**CONSTRUCTION BULLETIN
No. 002**

**Institution: California Institution for Men (CIM)
Project Name: Replace Roofs Phase 1
Construction Bulletin Number: 002
Date of Issuance: February 6, 2026**

Description: This Bulletin makes modifications and corrections to the Project Manual and Drawings as described below.

DATE: 11/03/2025
SHEET NUMBER
A2.6
16 OF 80 SHEETS V1

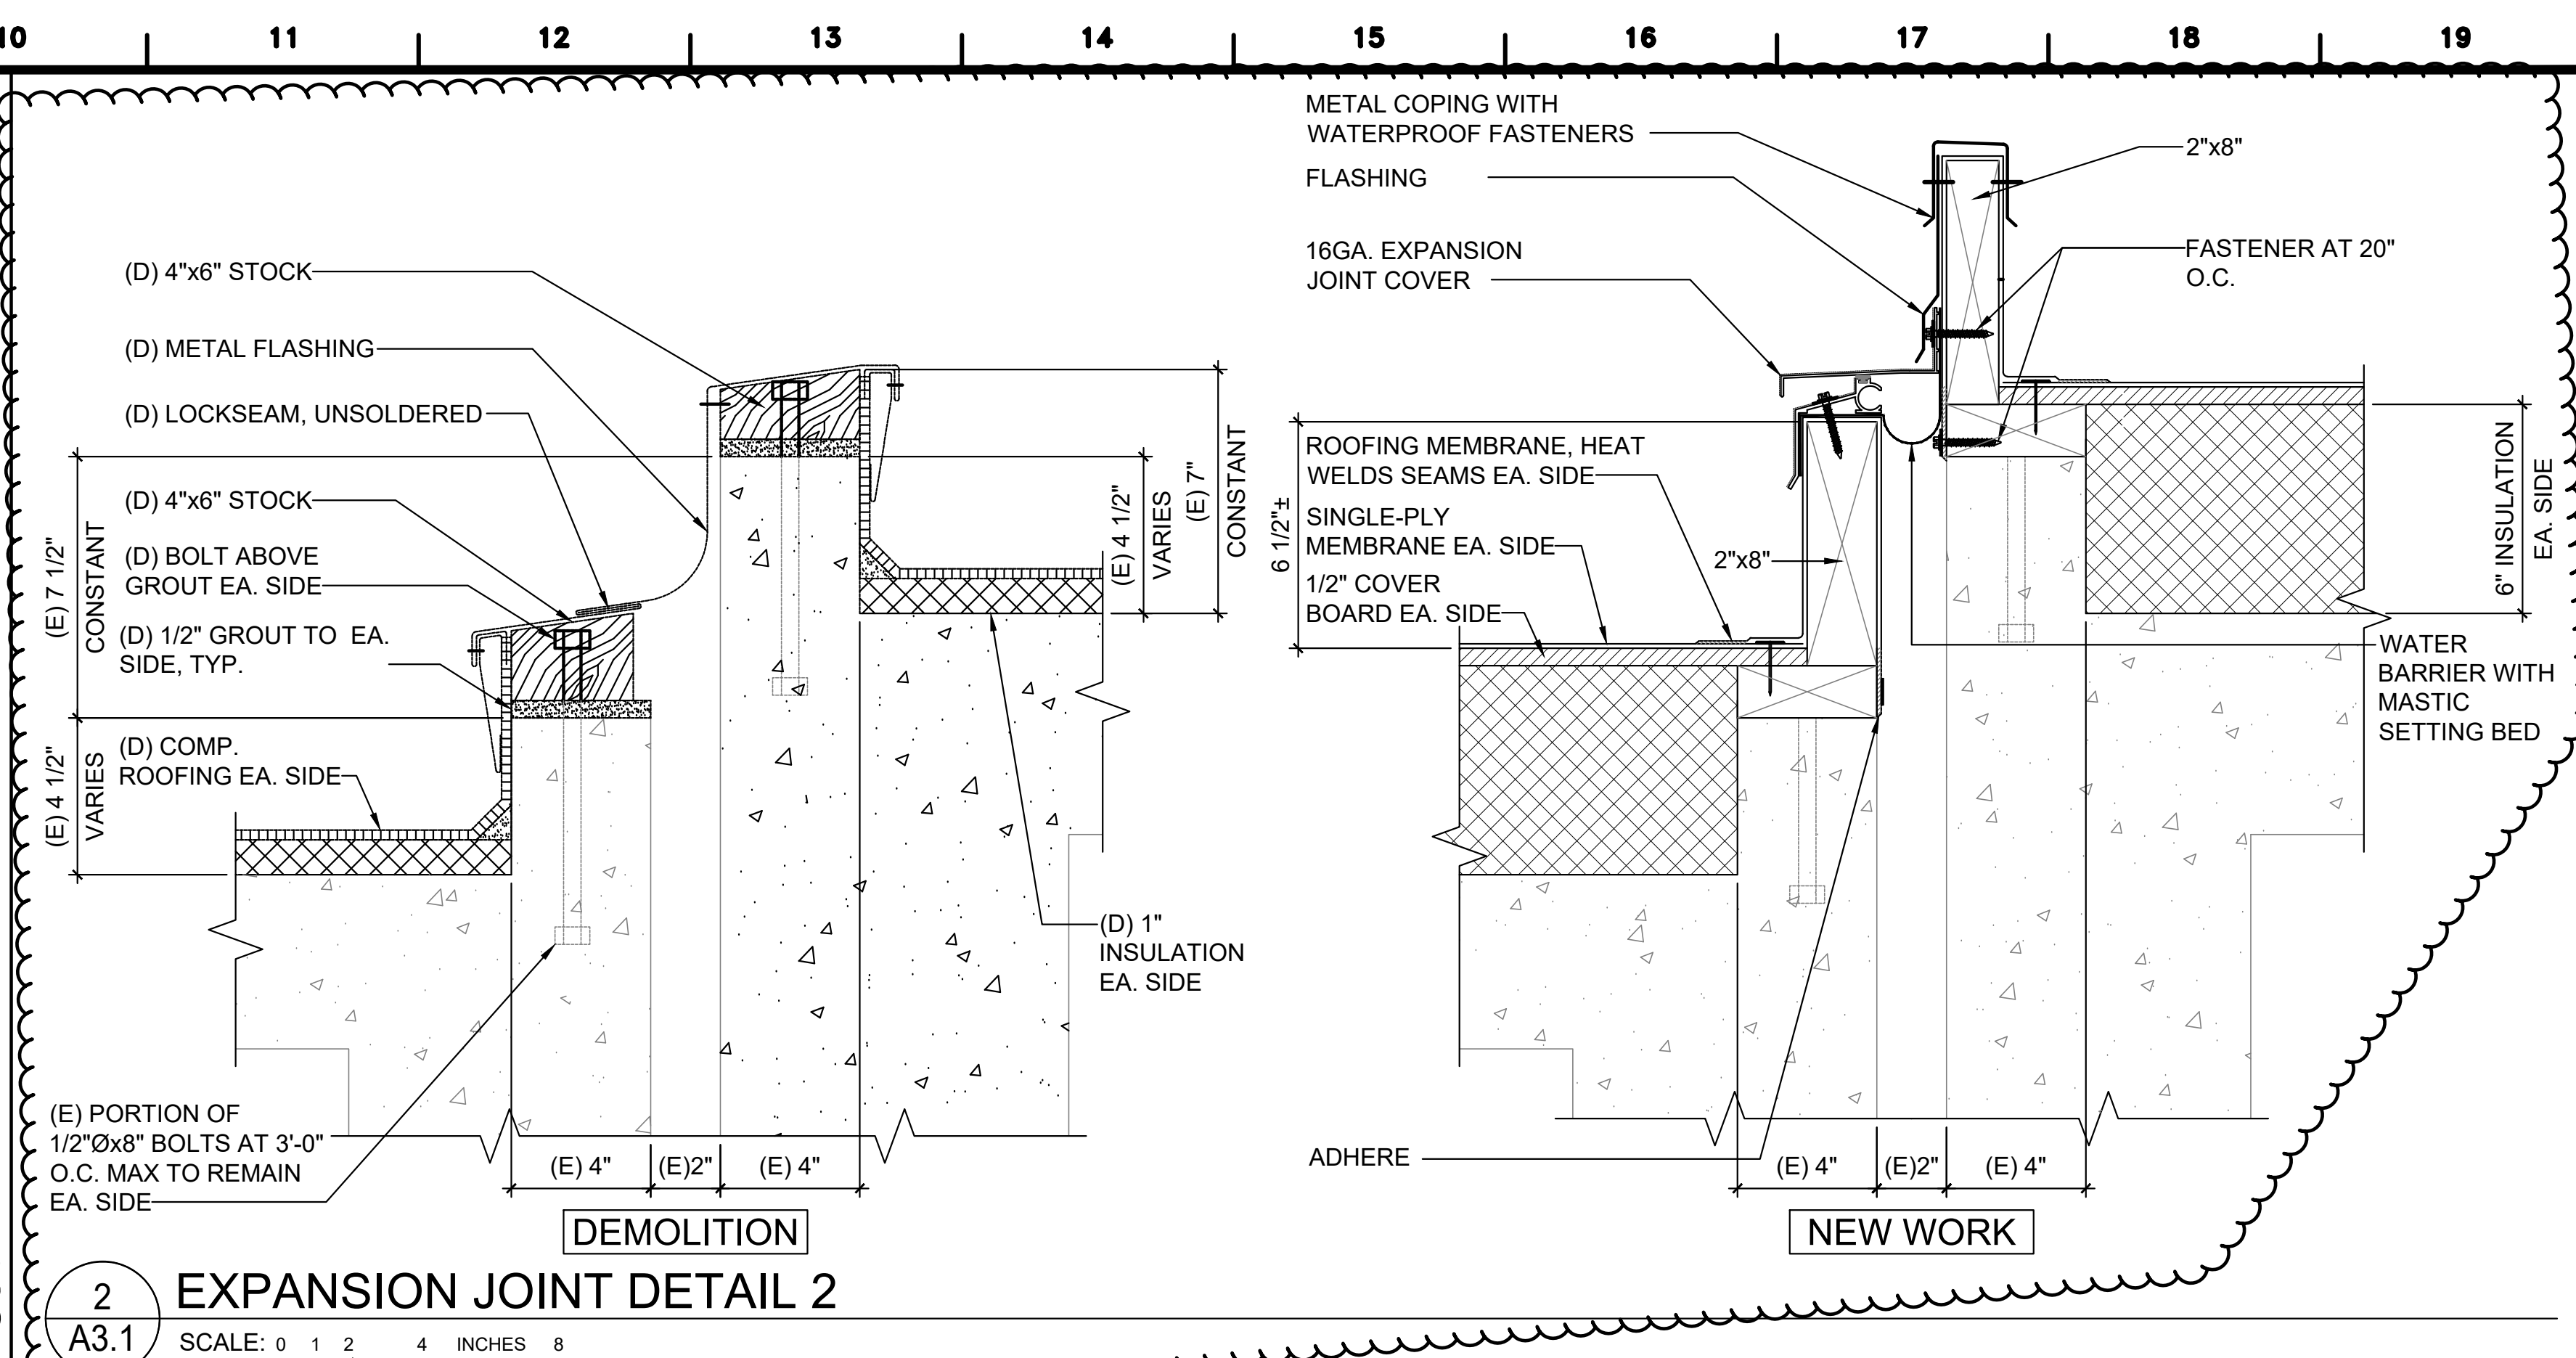
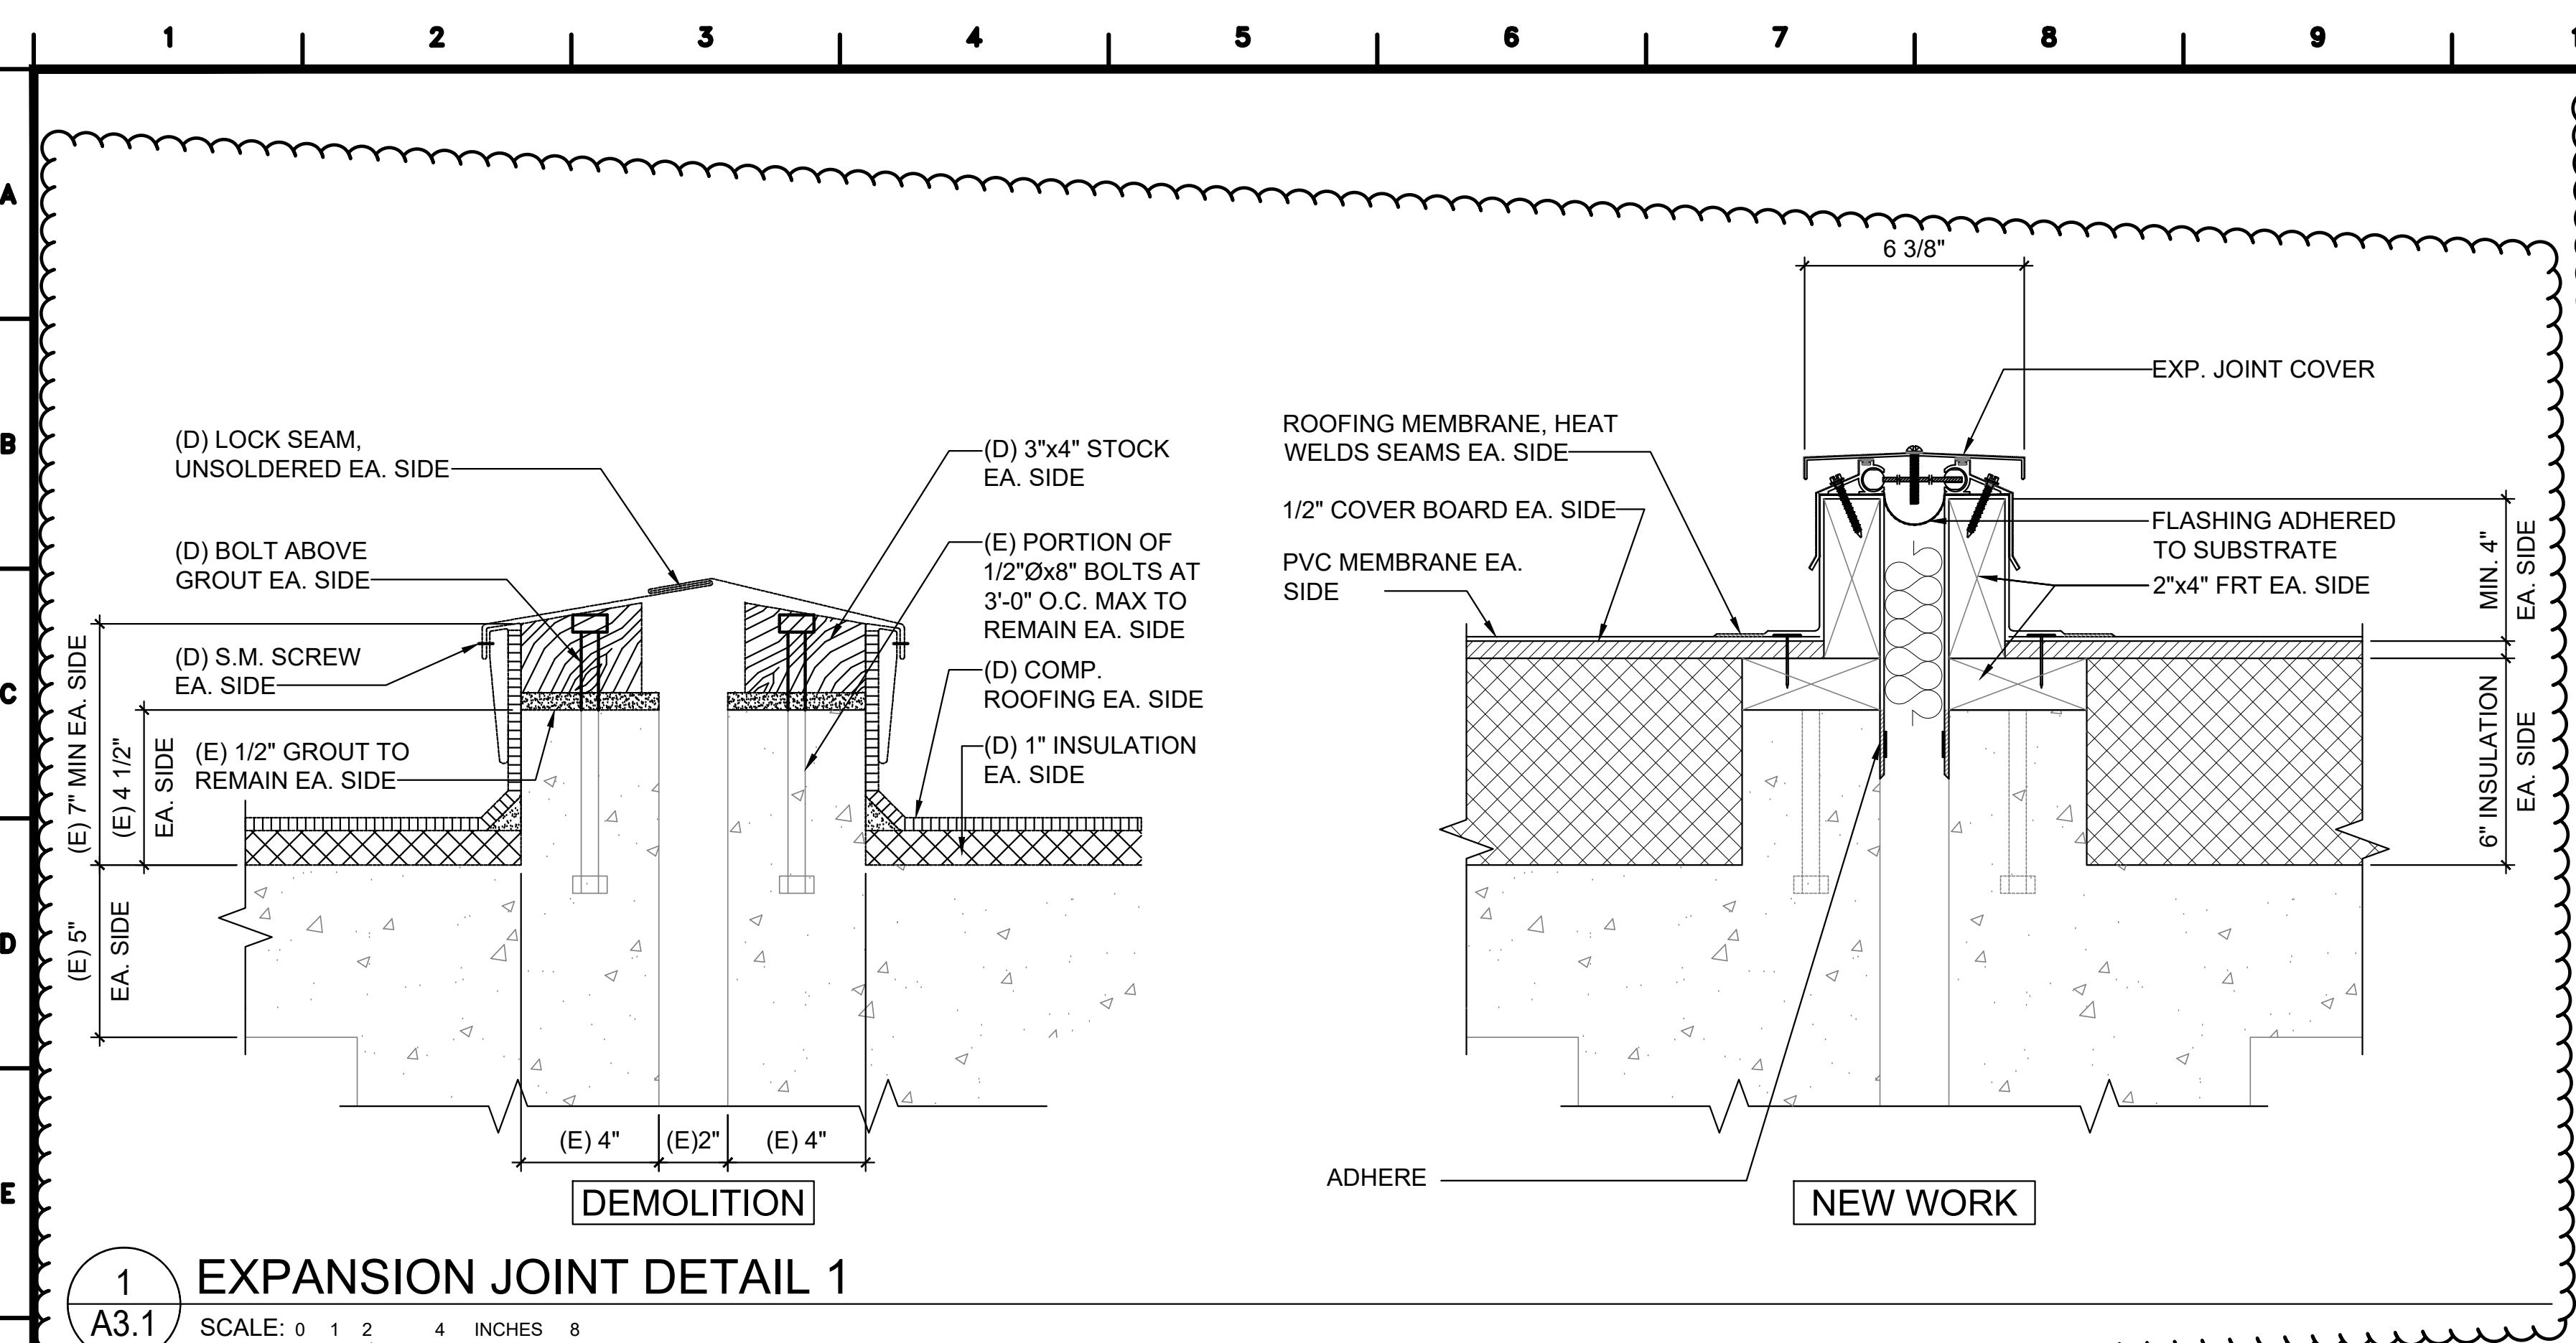
- tt. **Add** tag for DETAIL 7/A3.7
 - uu. **Change** tag for DETAIL from 2/A3.6 to 7/A3.7
6. Sheet A2.6 – UNIT 2 –ROOF NEW WORK PLAN
- a. **Add** NEW WORK KEYNOTE 16 reading PVC ROOFING WITH XPS TAPER INSULATION AT MECHANICAL PENTHOUSE SEE SHEETS A3.11 & A3.1

- b. **Add** NEW WORK KEYNOTE 17 reading REINSTALL (E) CAST-IRON DOME STRAINER AT (E) ROOF DRAIN
 - c. **Remove** LEGEND information regarding ELEVATION DATUM

- d. **Change** roof slope from 1:12 to 1/2:12
 - e. **Change** roof slope from 1/4:12 to 1/2:12
 - f. **Change** Roof Slope from 3/8:12 to 1/2:12
 - g. **Change** roof slope from 3/8:12 to 1/2:12

- h. **Change** roof slope from 3/8:12 to 1/2:12
 - i. **Change** roof slope from 7/8:12 to 3/4:12
 - j. **Change** roof slope from 7/8:12 to 3/4:12
 - k. **Change** roof slope from 7/8:12 to 3/4:12

- l. **Change** roof slope from 1 1/8":12 to 1:12
 - m. **Remove** roof slope 1/8:12

- n. **Remove** roof slope 1/8:12
- o. **Remove** roof slope 1/8:12
- p. **Remove** roof slope 1/4:12
- q. **Change** Roof Slope from 3/8:12 to 1/2:12
- r. **Change** tag for DETAIL from 2/A3.6 to 1/A3.5

- s. **Change** tag for DETAIL from 2/A3.6 to 1/A3.5
- t. **Change** NEW WORK KEYNOTE tag from 2 to 9
- u. **Change** NEW WORK KEYNOTE tag from 2 to 9
- v. **Change** tags for DETAILS from 2/A3.6 and 7/A3.7 to 6/A3.7 and 1/A3.5

- w. **Change** tag for DETAIL from 7/A3.7 to 6/A3.7
- x. **Add** cricket at exhaust fan
- y. **Add** NEW WORK KEYNOTE tag 8 at roof drain
- z. **Relocate** NEW WORK KEYNOTE tag 2

- aa. **Add** Mechanical Penthouse roof to scope of work.
 - 1) **Add** roof slopes
 - 2) **Add** dimensions
 - 3) **Add** NEW WORK KEYNOTE tag 16
 - 4) **Add** tag for DETAIL 3/A3.11

- 5) **Add** tag for DETAIL 2/A3.11
 - 6) **Add** tag for DETAIL 6/A3.11
 - 7) **Add** tag for DETAIL 7/A3.11

DATE: 11/03/2025
SHEET NUMBER
A3.8
24 OF 80 SHEETS V1

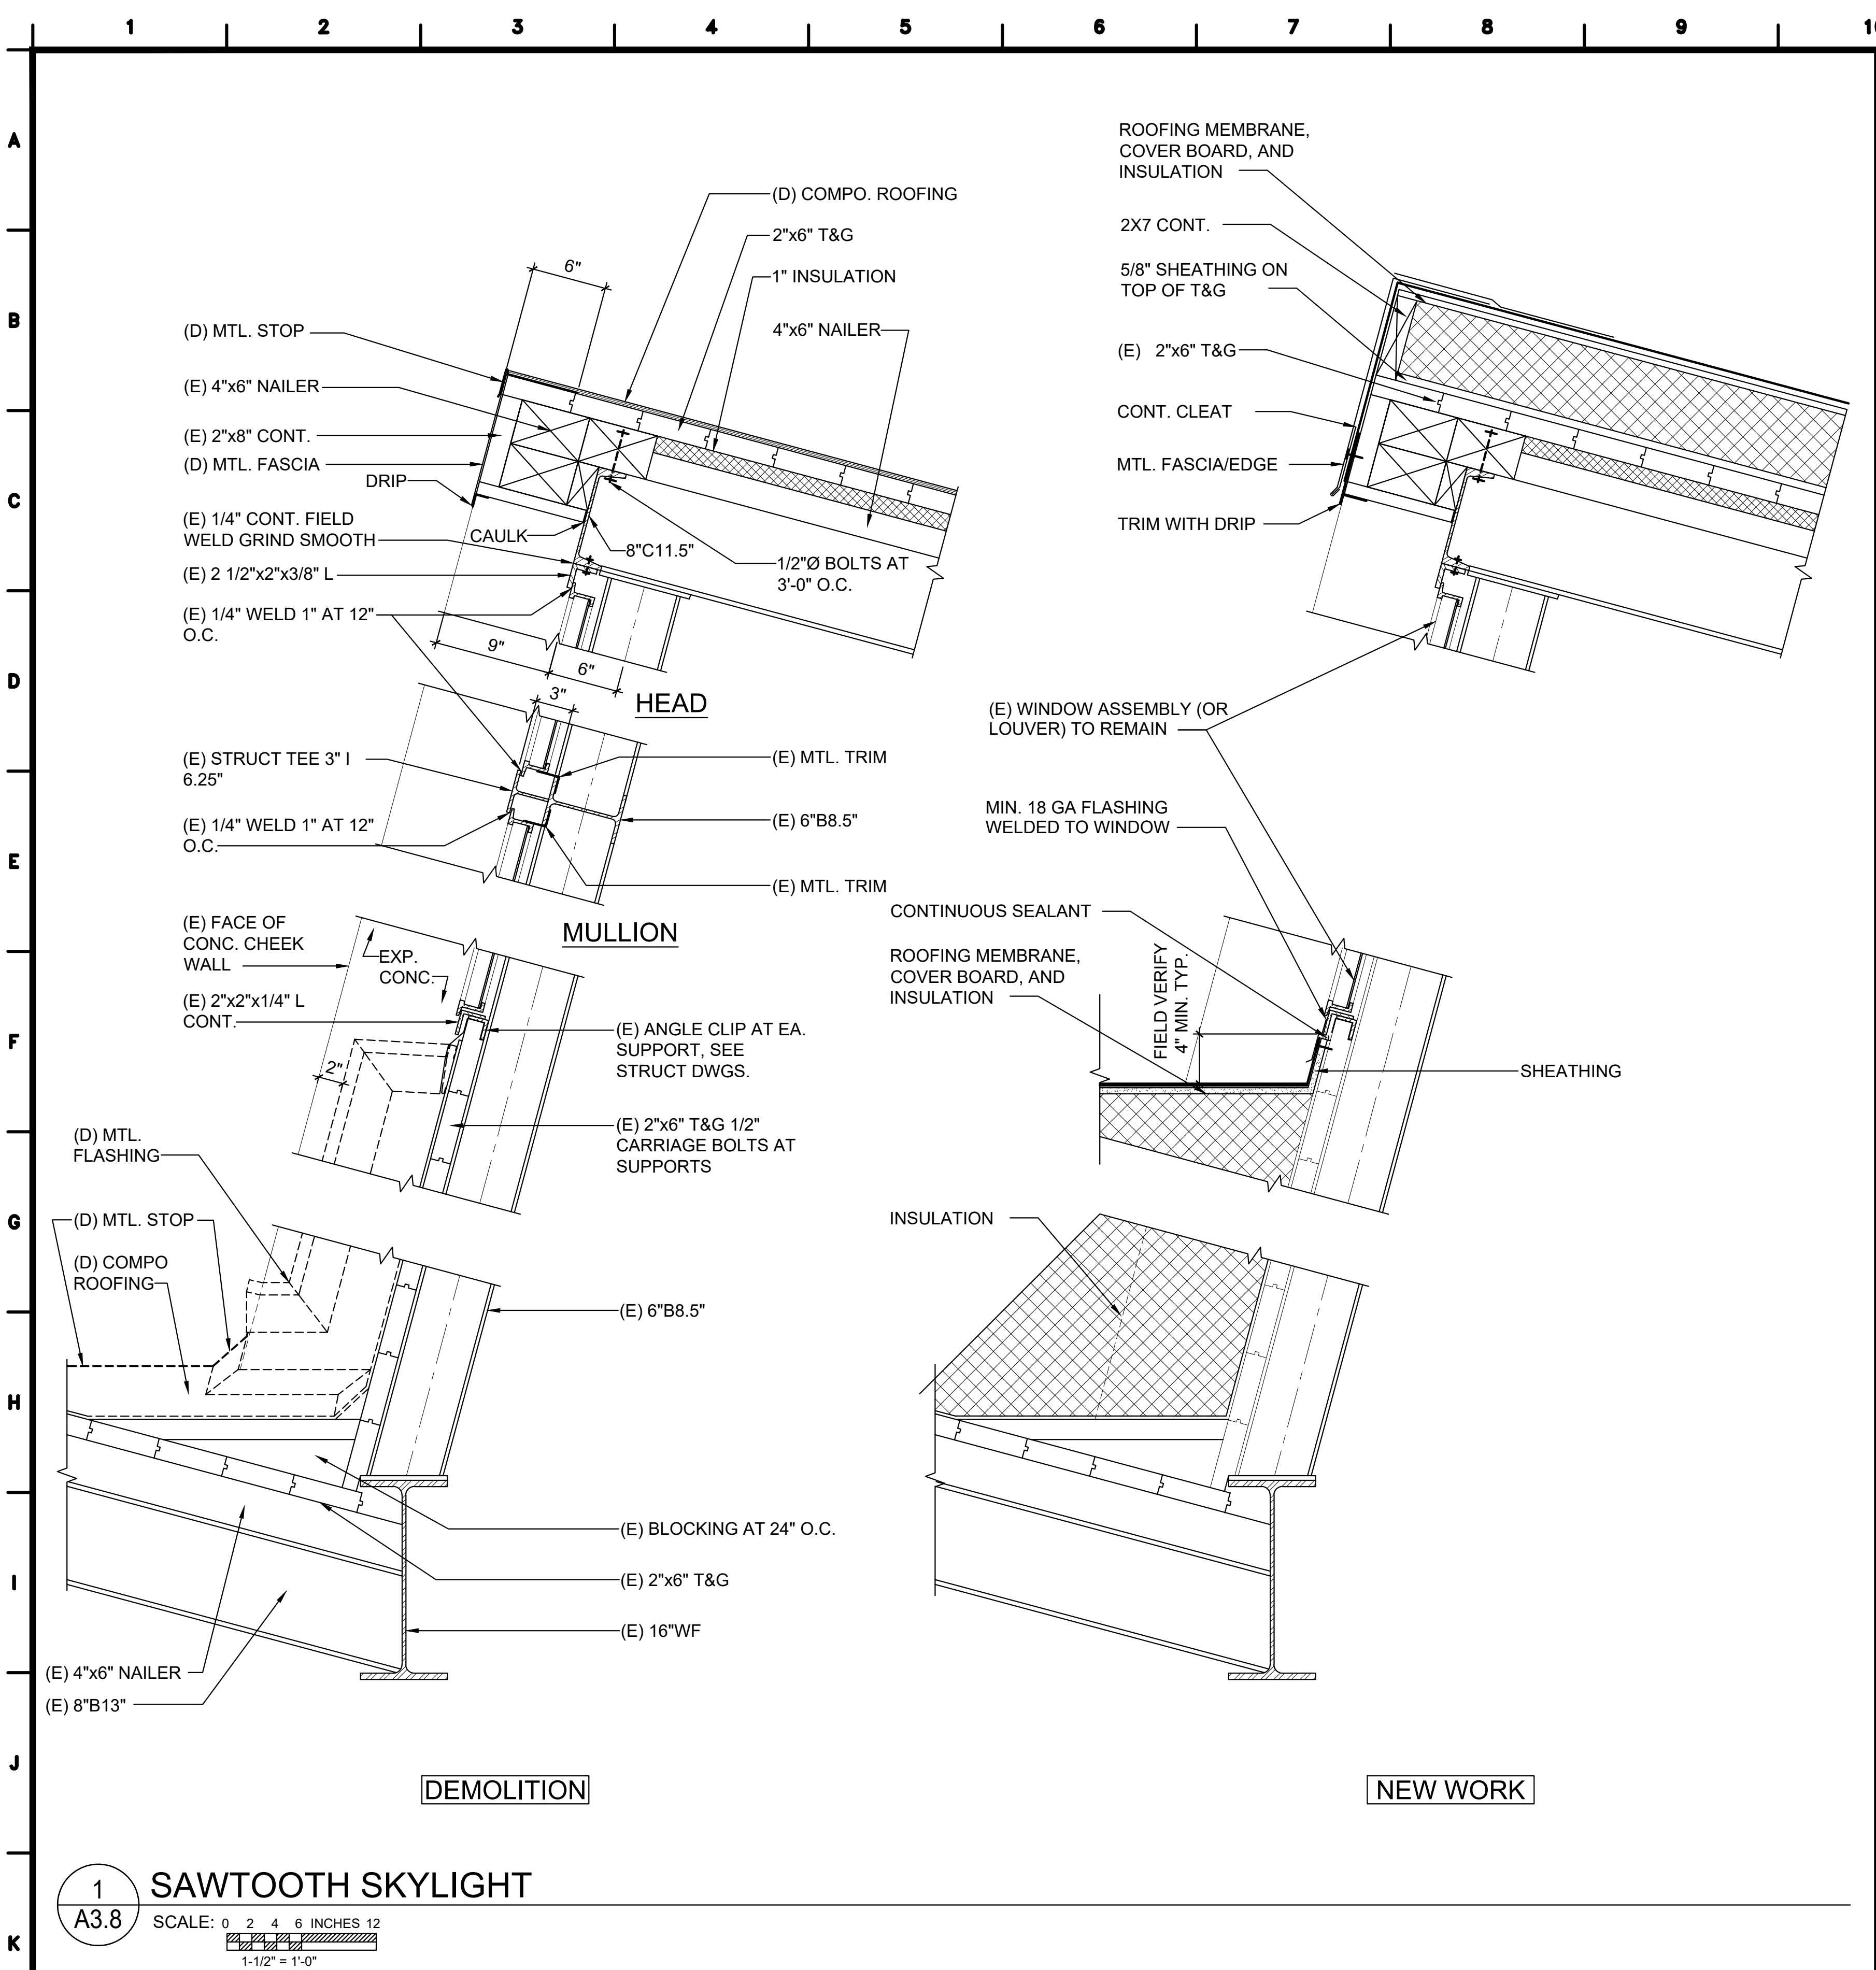
- b. **Add** DETAIL 7/A3.1
11. Sheet **A3.8 – DETAILS**
- a. DETAIL 2/A3.8
 - 1) **Add** note reading *SEE DETAIL 1 FOR NEW WORK
12. Sheet **A3.9 – DETAILS**
